Access Compliance Report

Intersection ID: 10589	Main Street: N_GRAHAM_ST	Cross Street: ARMOUR_DR	Location: E
ADA ID: 75EB80A34D54	Ramp Type: PerpDiag	Initial Pass/Fail: Fail	Overall Compliance: No
Severity Score: 12.5			
Codes/Mitigation Info/Possible Solution		Field Measurements/Component Compliance

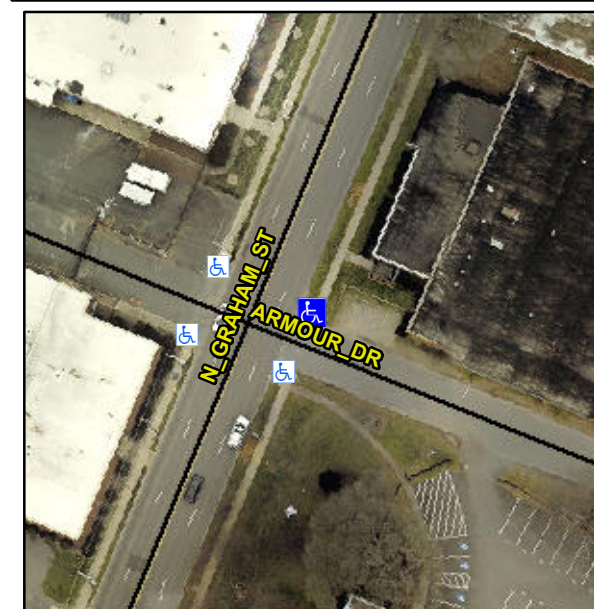
Not Found, R304.2.2

Compliance	Description	Data	Compliance	Description	Data
N/A	Ramp Length (in)	64.0	No	Ramp Slope (%)	8.6
Yes	Ramp Width (in)	48.0	Yes	Ramp XSlope (%)	0.4
N/A	Flare Type LT	N/A	N/A	Flare Type RT	N/A
N/A	Flare Slope LT (%)	N/A	N/A	Flare Slope RT (%)	N/A
N/A	Flare Traversable LT?	N/A	N/A	Flare Traversable RT?	N/A
N/A	Landing Length (in)	N/A	N/A	DWS Provided?	N/A
N/A	Landing Width (in)	N/A	N/A	DWS Contrast?	N/A
N/A	Landing Slope (%)	N/A	N/A	DWS Length (in)	N/A
N/A	Landing X Slope (%)	N/A	N/A	DWS Full Width?	N/A
N/A	Landing Curb? (Y/N)	N/A	N/A	DWS Offset (in)	N/A
N/A	Shared Landing?	N/A			
N/A	Gutter Ponding?	N/A	N/A	Gutter Slope (%)	N/A
N/A	Gutter Lip Ht (in)	0.5	N/A	Gutter X Slope (%)	N/A
N/A	Painted X Walk1?	No	N/A	Painted X Walk2?	No
	X Walk 1 Direction	To NW		X Walk 2 Direction	To SW
N/A	X Walk 1 Width (in)	N/A	N/A	X Walk 2 Width (in)	N/A
	X Walk 1 Slope (%)	0.8		X Walk 2 Slope (%)	0.0
	X Walk 1 X Slope (%)	0.2		X Walk 2 X Slope (%)	3.1

Remove & Replace Curb Ramp With Two New Directional Ramps or Equivalent.
